Application No: DA-950/2025/A
Date: 21/7/26

SECTION 4.55 PACKAGE

DEMOLITION OF EXISTING DWELLING AND CONSTRUCTION OF NEW DOUBLE STOREY SEMI - ATTACHED DUAL OCCUPANCY

35 DENNIS STREET LAKEMBA 2195 NSW

DRAWING TITLE
CROSS SECTIONS

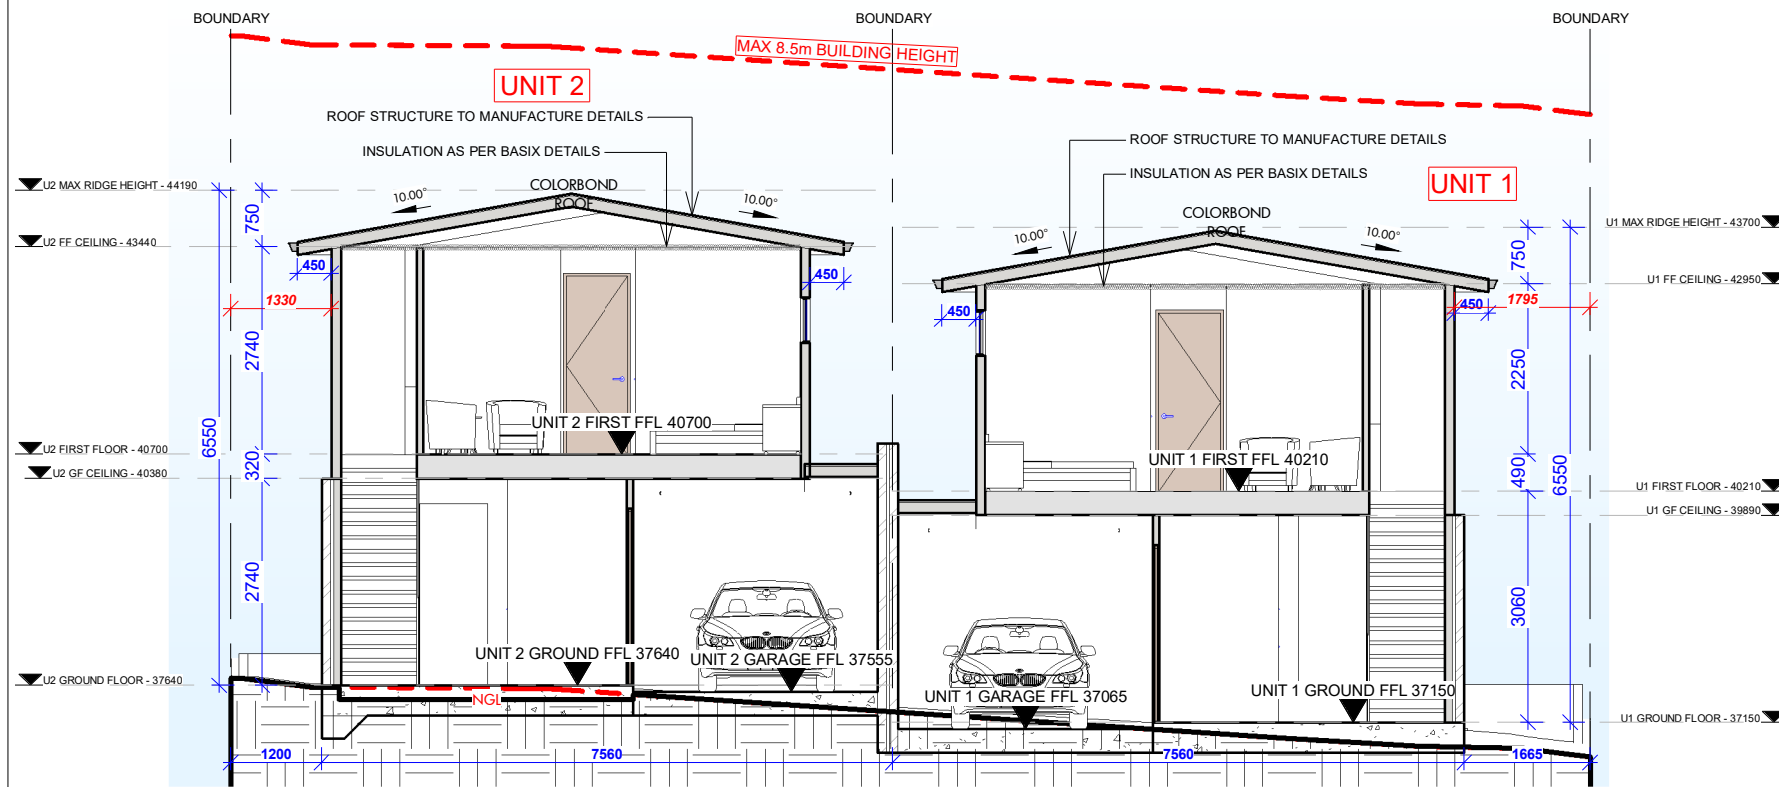
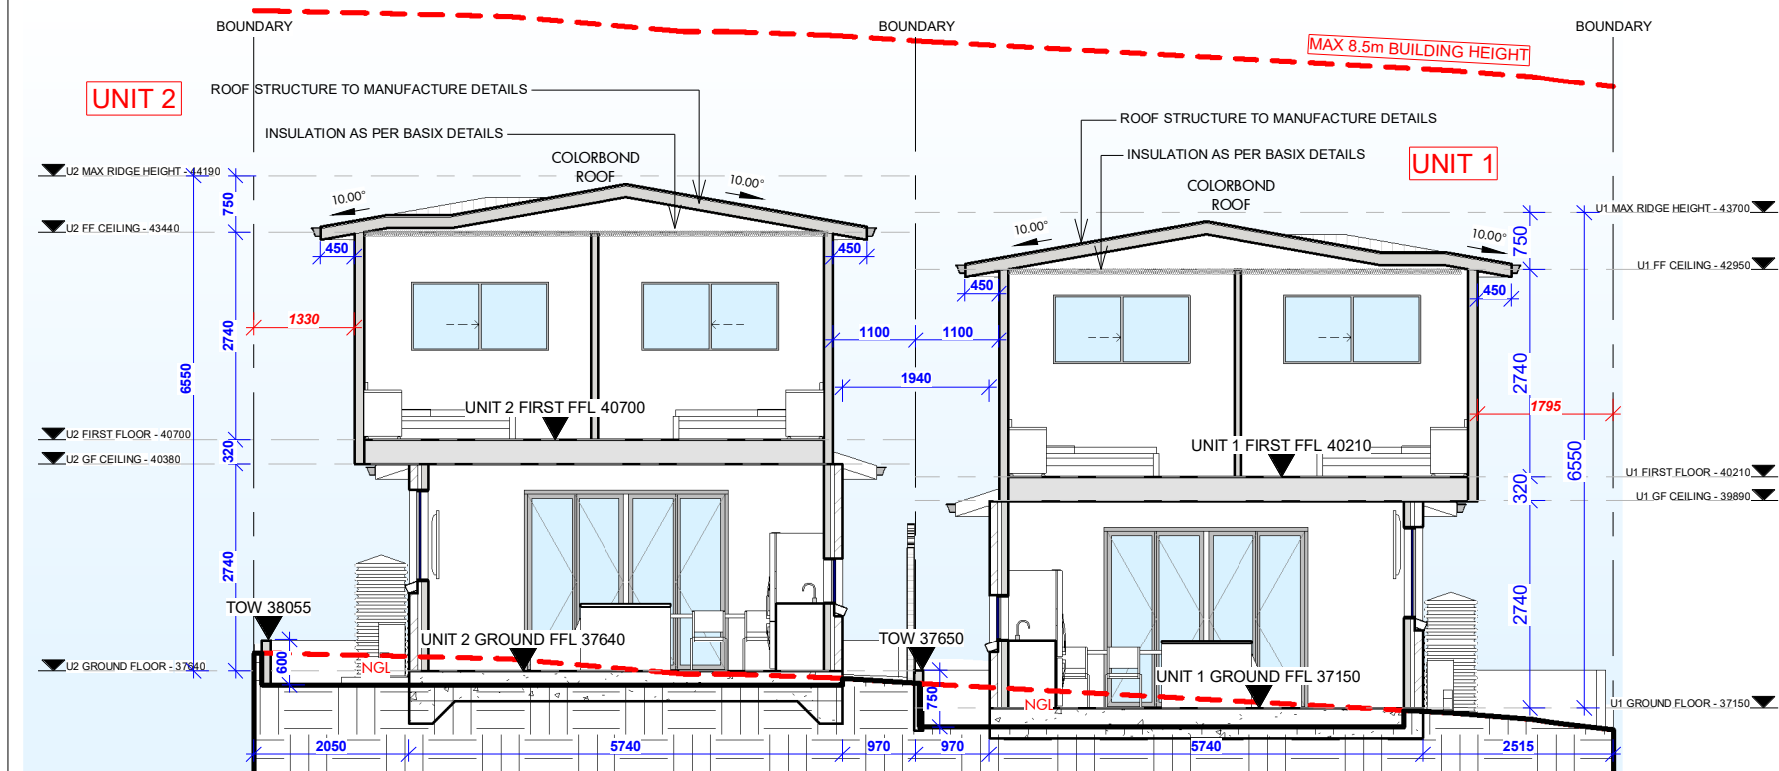
NOTE: SUBDIVISION WALL BETWEEN THE TWO HOUSES MOVED
ACCEDENTLY.
NOW CORRECTED IN SECTION 4.55 APPLICATION. NO OTHER CHANGE
PROPOSED.
